Accessibility Review Report – SSDA

Project Title: Crescent Parklands
1 Crescent Street, Holroyd

Job Number: 22626

Report Version: 22626_ADR_SSDA_v1.2

Figure 1 – Accessway to Stage B – Building 4 from Crescent Street.

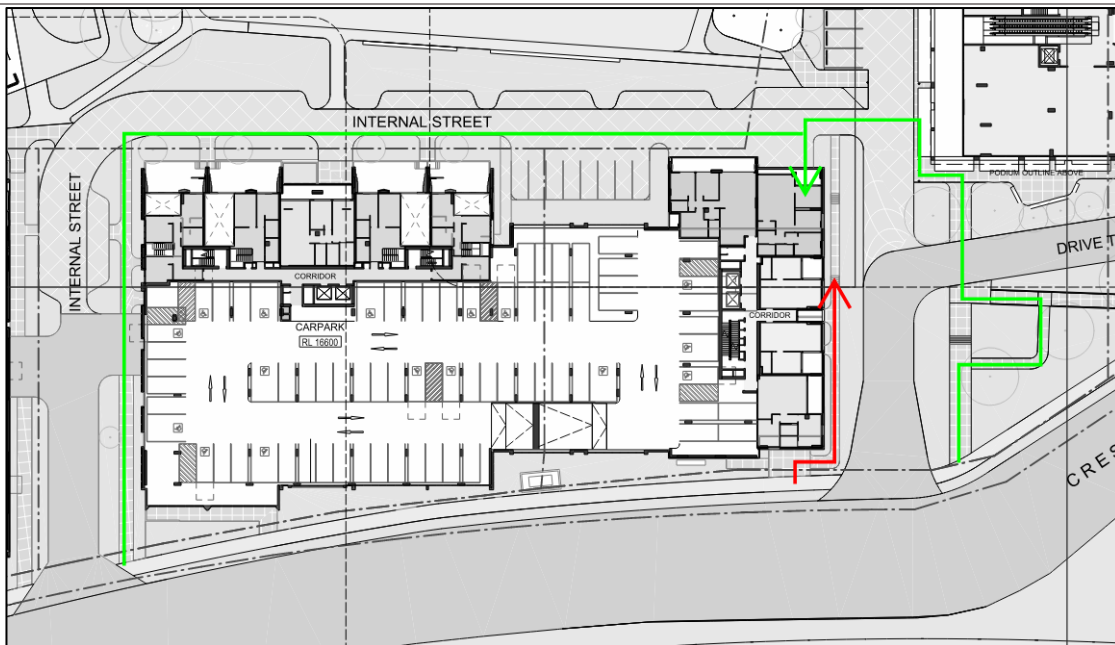
| 2 | <p>Further to the above, the Accessibility Review Report – SSDA dated 22 November 2024 states that buildings 4, 5 and 6 and 7 are identified as non-accessible entrances and will need to be addressed via a Performance Solution report. This should be addressed at the SSDA stage to avoid ‘chair lifts’.</p> | <p>An accessway to the entrances of Building 6 & 7 are now provided with the report. an accessible path of travel.</p> <p>The external pedestrian path of travel linking Crescent Street to Building 4 is proposed with the use of stairs (<i>refer red arrow in Figure 1 below</i>) due the the aggressive external height differences. This is a technical compliance departure to the BCA which will be requires to be addressed via Performance Solution Report.</p> <p>An accessway to the building is still provided via the adjacent external pedestrian pathways from Crescent Street as identified in green below.</p> | Table D4D3 of Section 2.0 of |

Issue 4:

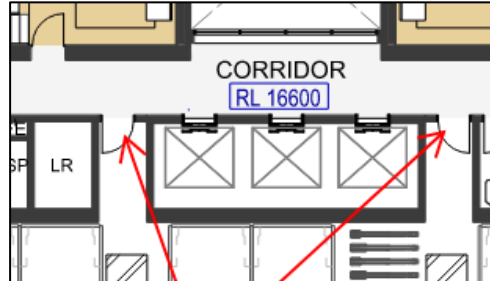
Building 6-7: Level 1-3: Doorways (x2) between lobby and carpark lacks a 530mm latch-side clearance to both approaches of the doorway.

To be redesigned to achieve compliance during detail design stage.

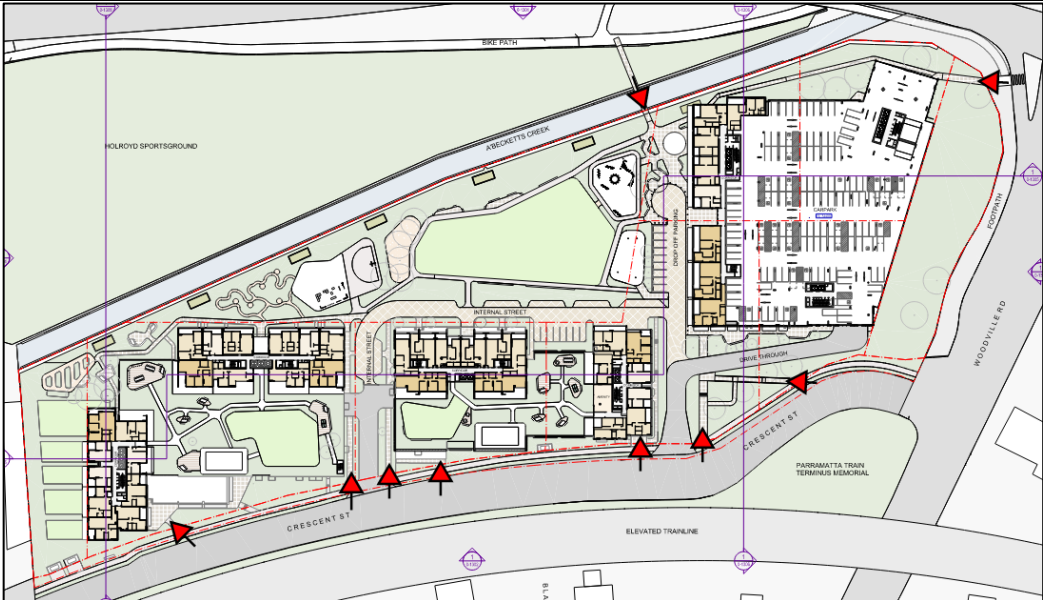
clients allotment or whether this is part of council's public domain. If part of the clients allotment, these feature will be required to achieve compliance with AS1428.1-2021. Pathways along the side of Stages B & C are indicated with pathways which do not meet AS1428.1-20021 compliance.  To be redesigned to achieve compliance during detail design stage. Further review of detailed building elements will be required as the design progresses.	
	<u>Other Accessible Buildings</u> A number of internal pathways are proposed throughout the site which link all buildings and all street frontages and external common use features. Drawings indicate that the internal pathways between all buildings link at an RL of 13000. The pedestrian link between buildings required to be accessible is to achieve compliance with AS1428.1-2021. Further review of detailed building elements will be required as the design progresses.	CoC
